Generic Environmental Impact Statement for License Renewal of Nuclear Plants

Supplement 38

Regarding Indian Point Nuclear Generating Unit Nos. 2 and 3

Draft Report for Comment

3 **Figure 4-3. Percentage of entrainment composed of RIS fish and total identified fish**
4 **relative to the estimated total entrainment at IP2 and IP3 combined**
5 **(data from Entergy 2007b)**

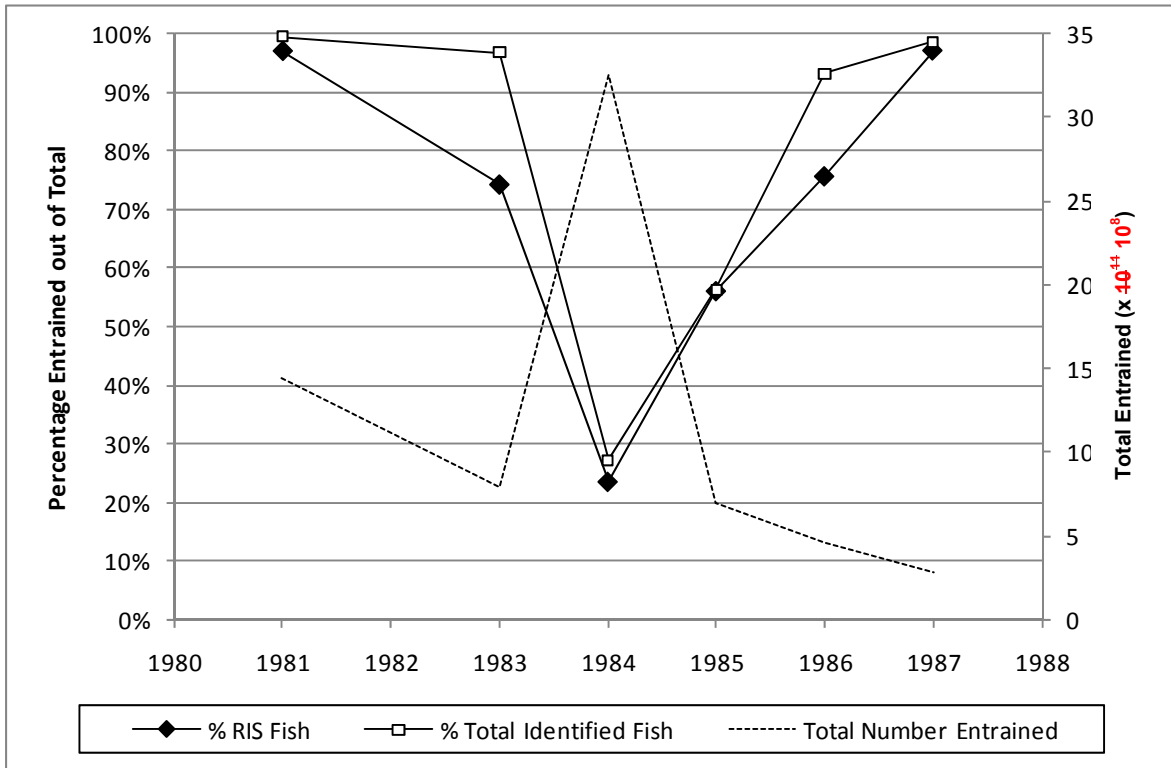
In the FSEIS, the NRC staff estimated the number entrained for a given week as the product of the mean density entrained and the combined weekly flow for IP2 and IP3. The error in the entrainment catch density directly affects Figure 4-3 in Section 4.1.2, and the error is repeated in Figure H-5 in Appendix H. In these figures, the total number entrained on the right axis should be in units of numbers $\times 10^8$ instead of numbers $\times 10^{11}$. The corrected Figures 4-3 and H-5 appear below. In addition, these changes affect two portions of text in the FSEIS.

1 **Figure 4-3 on page 4-15 in the FSEIS is corrected as follows:**

4 **Figure H-5. Percentage of entrainment composed of RIS fish and total identified fish**
 5 **relative to the estimated total entrainment at IP2 and IP3 combined**
 6 **(data from Entergy 2007b)**

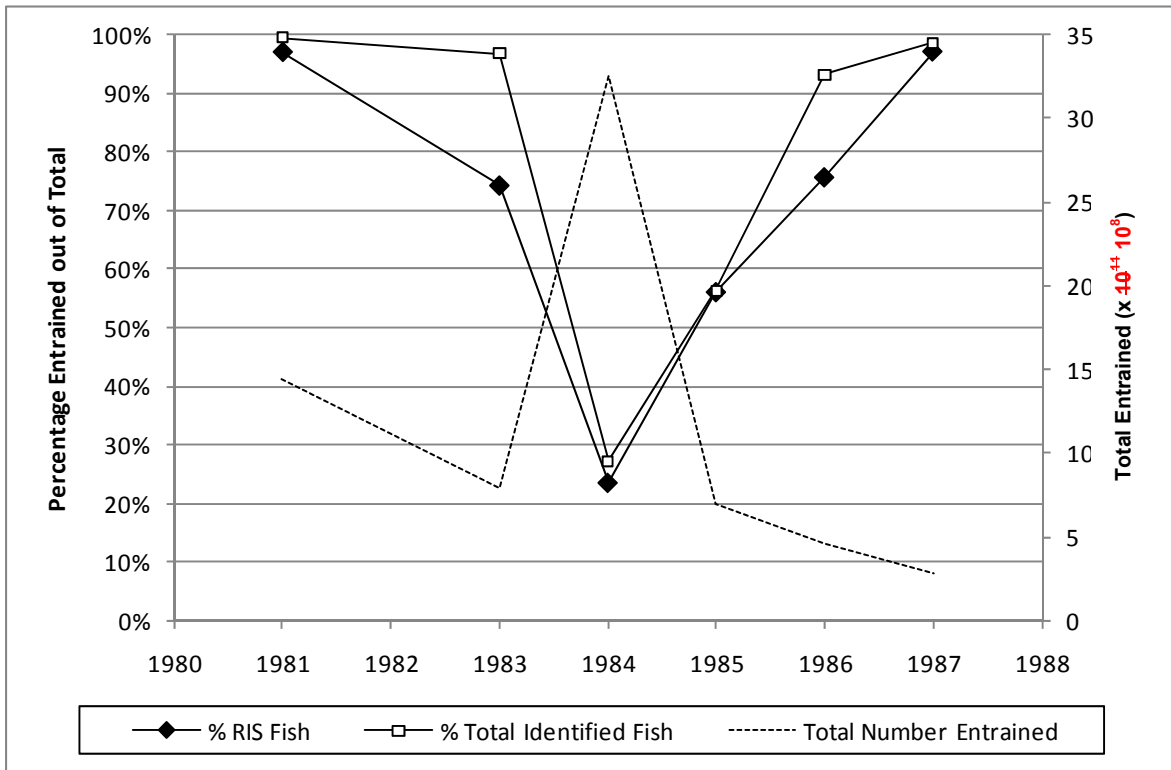
1 **Figure H-5 on page H-23** in the FSEIS is identical to Figure 4-3 in the FSEIS and is corrected
 2 as follows:
